Appendix 1: Recommended amendments to the Proposed District Plan

TR — Transport

Proposed District Plan Hearings Panel – Stream 6 – Transport

Figure 3 — Motor vehicle parking

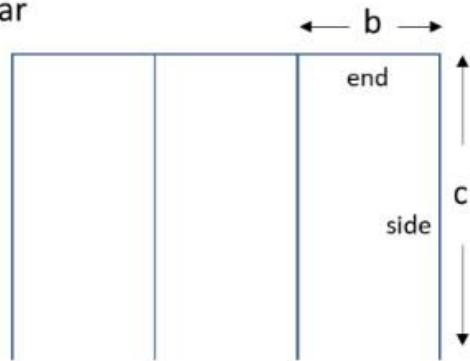
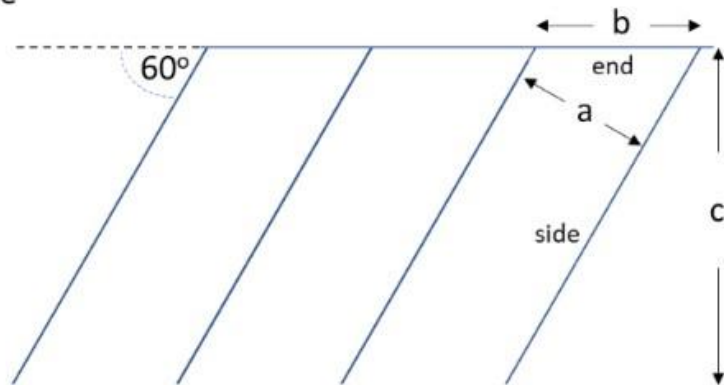
Laura Skilton	314	72	Support in part	Seeks that the table and figure are amended to: - align with the NZS2890.1 update - change the "b" dimension in "parallel" and "perpendicular" in the figure to be the "a" dimension - clarify that "Minimum aisle width" = manoeuvring (refer TR-S8.4 etc) - simplify the table (refer to original submission for further detail)	Accept in part
Laura Skilton	314	73	Neutral	Amend title of figure as follows: "Figure 3 – Motor vehicle Car parking"	Accept in part
Adrian Palmer Family Trust	315	16	Amend	Seeks that rule is amended by deleting sub-clause 2(b) so that the provision of more than 10 car parking spaces is a permitted activity.	Reject
Rowan Swain & Kim Weber-Swain	317	12	Oppose in part	Remove the Highly Constrained Roads Overlay from Waitohu Rd, York Bay OR, HCC to provide the engineering assessments on the condition of the road and why additional traffic is a major risk, traffic reports into crash history, what traffic mitigations have been considered by HCC.	Reject

2. Motor vehicle parking ~~Carparking~~ spaces and manoeuvring areas must:
 - a. Comply with the minimum dimensions of Figure 3: Motor vehicle parking and Table 5: Design requirements for motor vehicle parking,

Commented [PM12]: See Laura Skilton (314.69, 314.72)
